Basic Development Plan Review & Basic Site Plan Review

15-002BPR/PP – Bridge Park East

Mixed-Use Development Project – Riverside Drive and West Dublin-Granville Road

Building Number Diagram

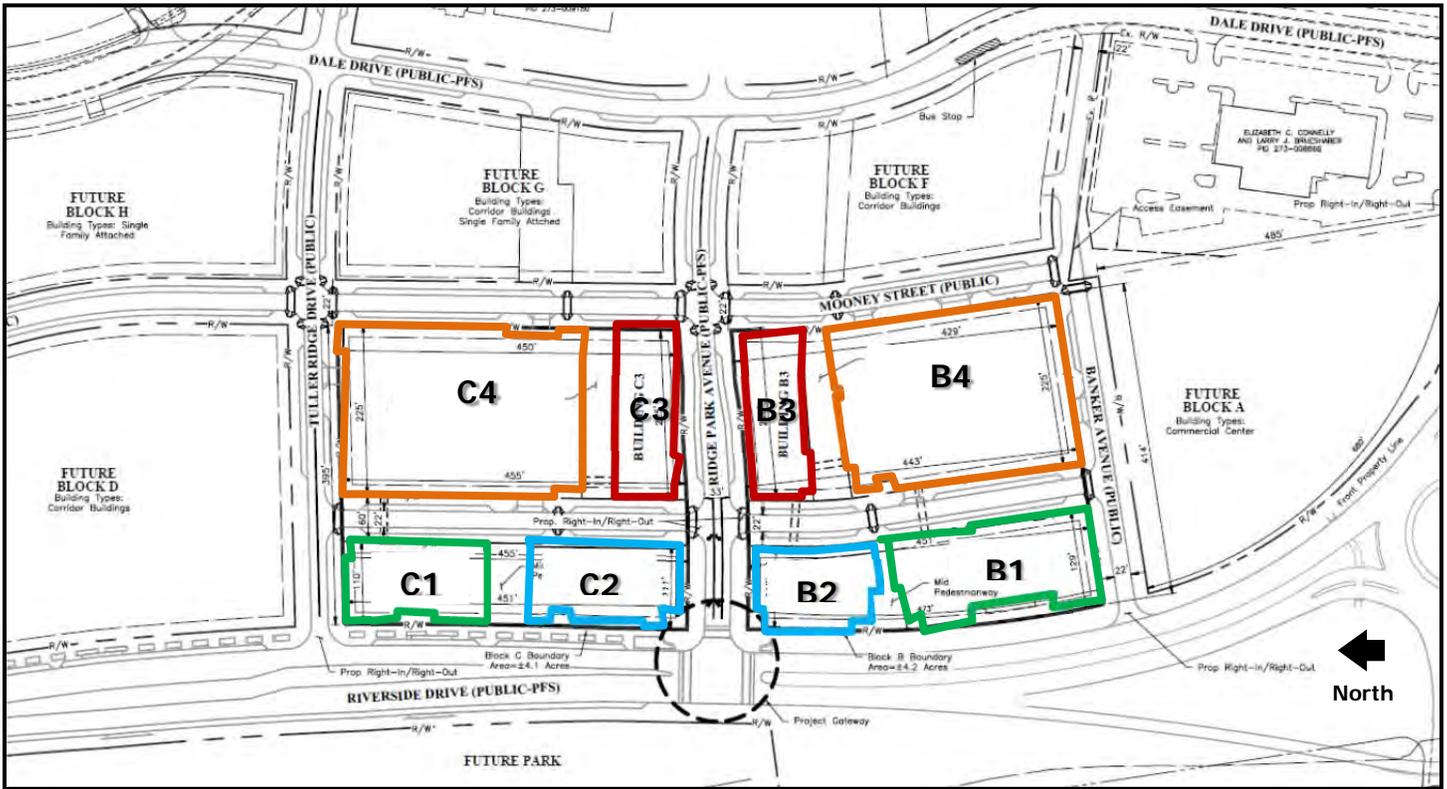
- Non-Street Façade Transparency Requirements/Blank Wall Requirements: These requirements are not met on Buildings B1, B3, B4 (Residential elevations), C1, and C4 (Residential elevations) on elevations facing the open spaces between the buildings. With additional design consideration for these elevations consistent with the *Framing Open Spaces* comments above, the intent of these requirements will either be met, or approval of Waivers may be considered at Site Plan Review.

- Building Entrances: Several of the buildings fail to provide the minimum number of required building entrances (B4 (Residential), B4 (Garage), C1, C2, C3, C4 (Residential), C4 (Garage)). To ensure pedestrian connectivity and accessibility throughout the site, the plans should be modified to include the required pedestrian entrances, or justification for potential Waivers at the Site Plan Review. The applicant should consider providing external entrances to the individual dwelling units on buildings B4 and C4 as one way to meet the requirement and enhance the pedestrian-oriented environment along Longshore Street and Mooney Street, respectively. The parking garages should also be modified to provide additional pedestrian entrances, particularly at the tower locations.

- Vertical Increments Required: The intent of the vertical increment requirement is to break up the massing of longer buildings through specific methods identified in the Code, such as recesses and projections along the facades. However, most of the buildings incorporate storefronts that may meet the intent of this requirement once additional details are known, although the elevations on B4 and C4 should be modified to incorporate additional vertical elements since they do not have storefronts. This requirement applies to buildings B1, B2, B3, B4 (Residential), B4 (Garage), C1, C3, C4 (Residential) based on this preliminary analysis.

- Horizontal Façade Divisions: While Waivers to the Horizontal Façade Division requirement may be considered appropriate for some of the buildings (refer to the Site Plan Waiver analysis in the next section of this report), the plans should be modified to meet this requirement for Buildings B4 (Garage), C4 (Residential), and C4 (Garage), or provide justifications for a Waiver at the Site Plan Review.

- Upper Story Street Facing Transparency Requirements/ Ground Story Street Facing Transparency Required: These two categories of transparency requirements (affecting buildings B1, B2, C1, C3 and B3, B4 (Residential), C1, C4 (Residential), respectively) are either very close to meeting the requirement, and therefore the applicant should either modify the plans or provide additional justification for potential Waivers.

- RBZ Requirements: The Required Building Zone (RBZ) requirement for parking garages on corner side property lines is a minimum setback of 5 feet up to a maximum of 25 feet. Both proposed garages (buildings B4 (Garage), C4 (Garage)) have a minimum setback of 0 feet (situated on the property lines). The intent of this requirement is to provide a buffer along the public realm and soften the edge of these buildings. The applicant should coordinate revisions to the elevations on these sides of the parking garages to enhance the pedestrian experience and meet the RBZ requirement, or provide justification for a Site Plan Waiver.
